MEMORANDUM

TO: Tukwila City Council
FROM: Carol Lumb, Senior Planner
CC: Mayor Haggerton
Rhonda Berry, City Administrator
Bob Sterbank, City Attorney
DATE: November 4, 2009
SUBJECT: Packet #7 - Handouts

Tukwila City Council SMP Work Session

SECOND REVISED SUMMARY SHEET SECTION 3
NOVEMBER 4, 2009

MINIMUM Preferred Levee Profile
Not To Scale

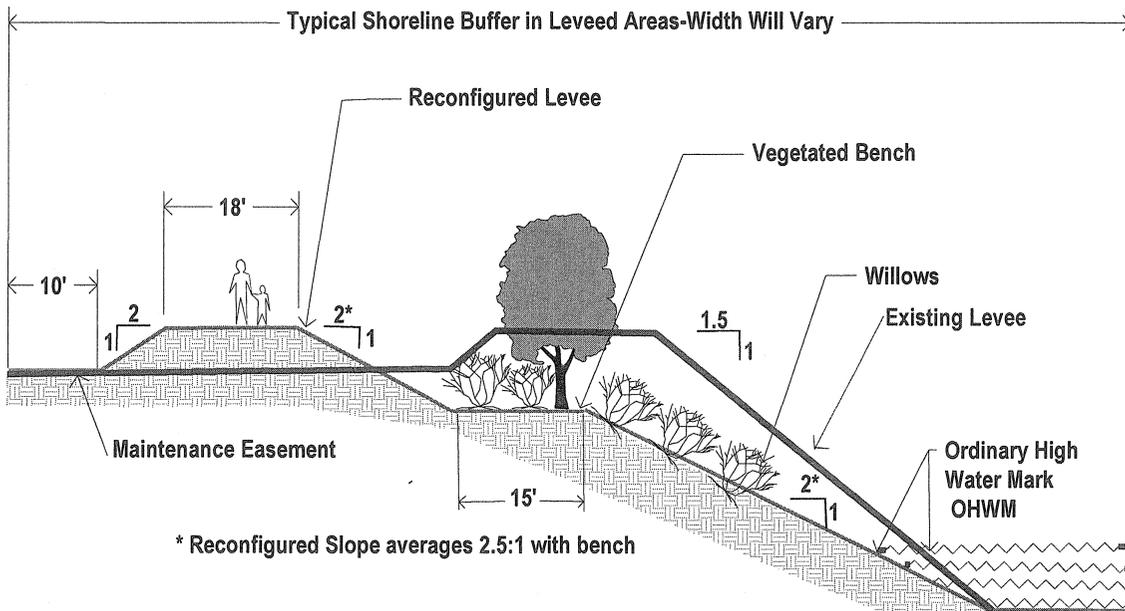
It has come to staff’s attention that the use of the term “preferred” can be read to imply that the use of the profile illustrated above is preferred but not required. The text in Section 7 makes clear that the profile illustrated above is required, however, to make sure

this is clear, staff recommends changing the terminology to “Minimum Levee Profile.” If the Council agrees, the title of the illustration above will be changed and all references in the document to “preferred levee profile” will be changed to “minimum levee profile.”

Levee, Preferred Minimum Profile: shall mean, where there is room, the preferred levee profile for any new or reconstructed levees is the King County “Briscoe Levee” profile – 2.5:1 overall slope with 15 foot mid-slope bench for maintenance access and native vegetation plantings. Where there is insufficient room for a levee backslope due to the presence of existing structures, a floodwall may be substituted. See Figure X for an illustration of the preferred profile.
